2408116

Map 281.1-1000

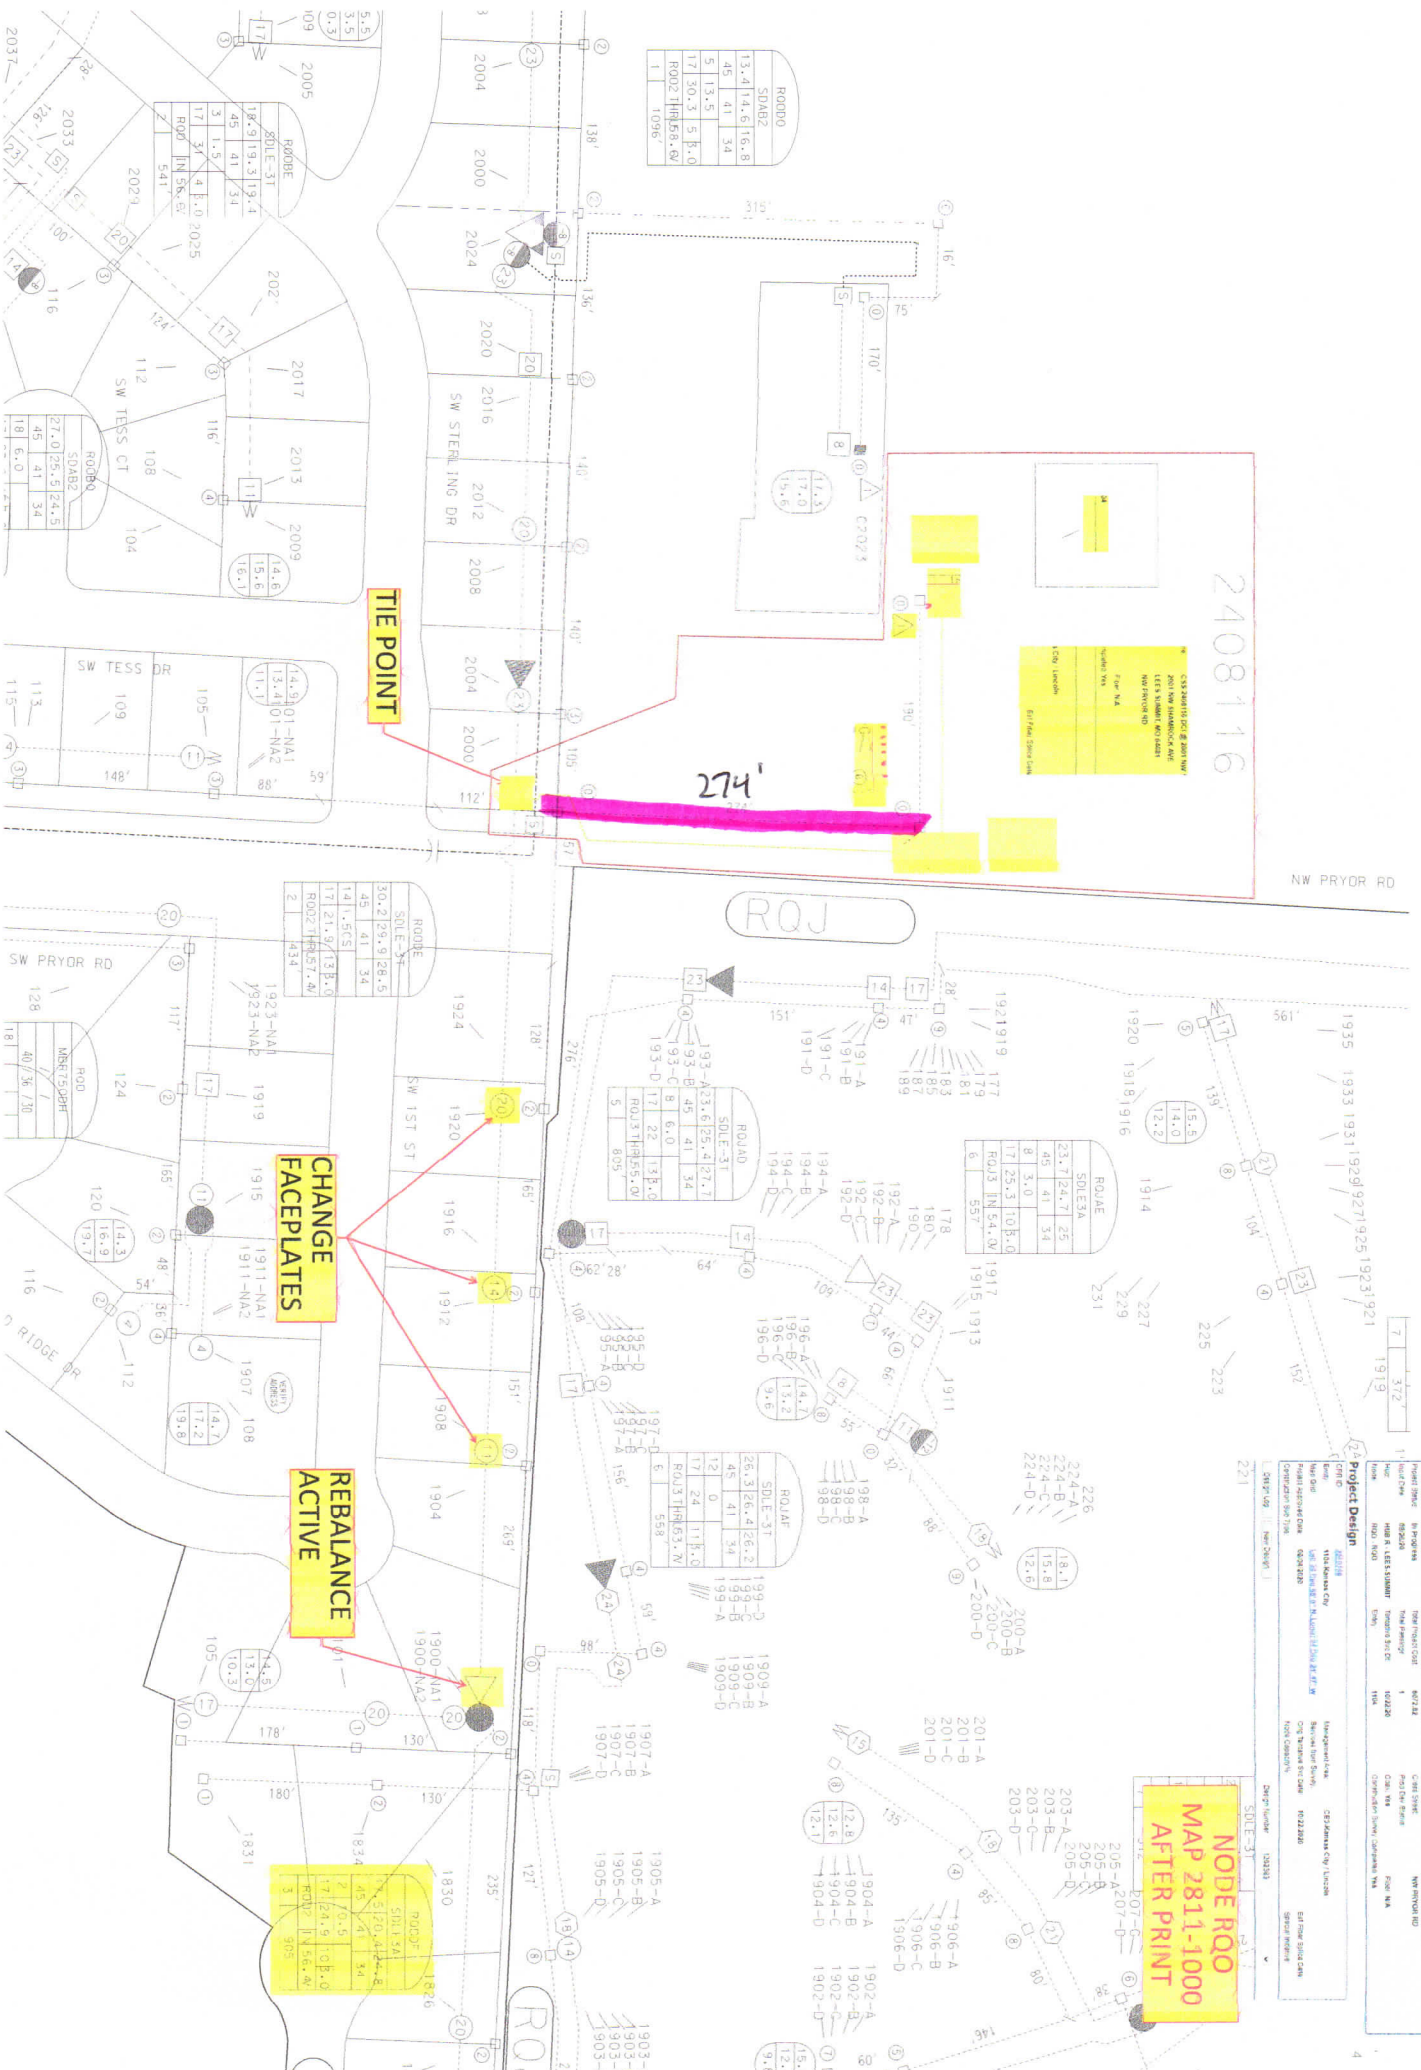
CHANGE
FACEPLATES

REBALANCE
ACTIVE

NODE RQO
MAP 281.1-1000
AFTER PRINT
